AR 3201 # 13690

SERVICE BULLETIN

SERVICE BULLETIN AR 3201 - 3/92

SUBJECT : Synthesizer Modules AR 3201

Fig 1: Location of battery Bat. 3051 on Synthesizer Module 28110 - 13000.000

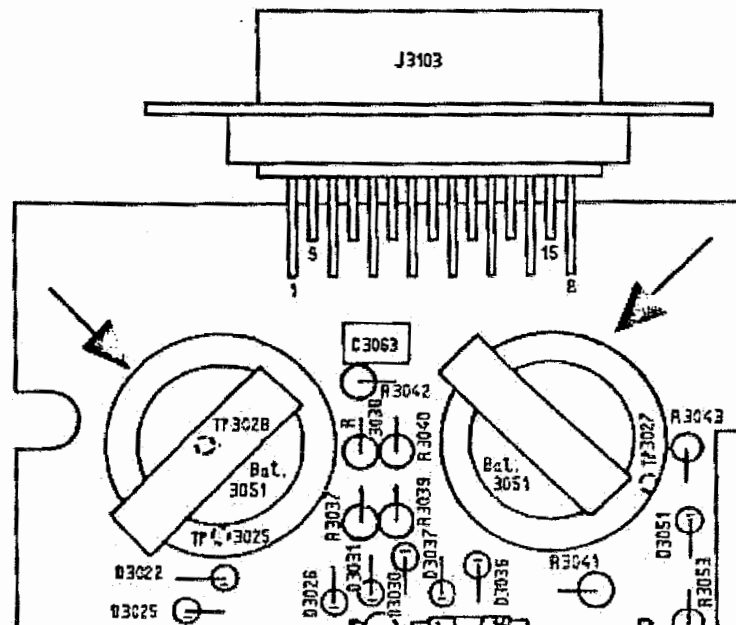
1. Determine manufacturing date of the Ni/Cd-battery. Since 1986 there is a marking on the battery's label (Bat. 3051 and Bat. 3052 or Bat 3001) which describes the manufacturing date.
For example : 8707 means manufacturing date: 7th calendar week 1987
2. If the batteries are more than 4 years old it is recommended to replace the batteries, even if there is no visible damage.
3. Carefully check the battery connectors and the surrounding components for sediments
4. If there are any damages, remove the battery and surrounding components in order to get access to the contaminated printed conductors for cleaning. Use alcohol (methyl alcohol 94%) and a glass-brush for cleaning. Any component removed should be replaced with a new part.
5. If battery replacement is necessary, insert and solder new batteries as shown in Figures 1 to Figure 5.
Ensure correct polarity!

Fig. 5: Location of battery Bat. 3001 on new Synthesizer Module 28141 - 13000.000

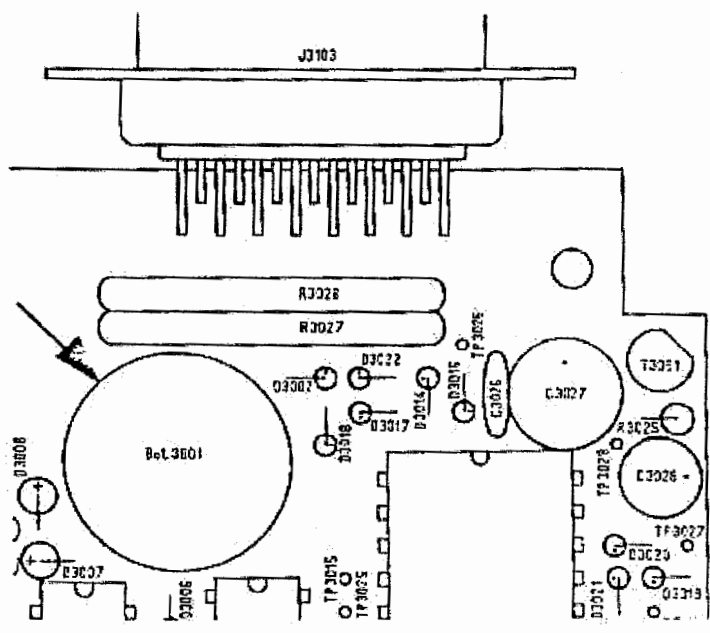
My module
